GRPE A-LCA IWG SG5(EoL) Meeting 026

6th Nov. 2025

GRPE A-LCA IWG SG5
Leader; Hiroyuki SUZUKI (JASIC/JAMA)
Co leader; Zhang Tongzhu (CATARC)

Wording inconsistency between 7.1, and 8.4.

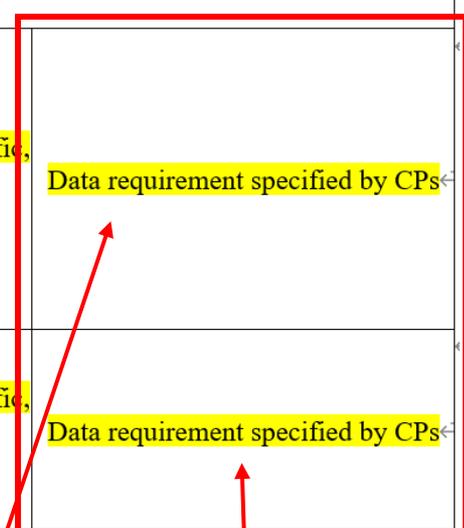
Not aligned

Drafting update proposal

Aligned with small modification

Global or Region or Country primary data or secondary data shall be specified and provided by CPs	Global or Region or Country process shall be specified and provided by CPs
---	--
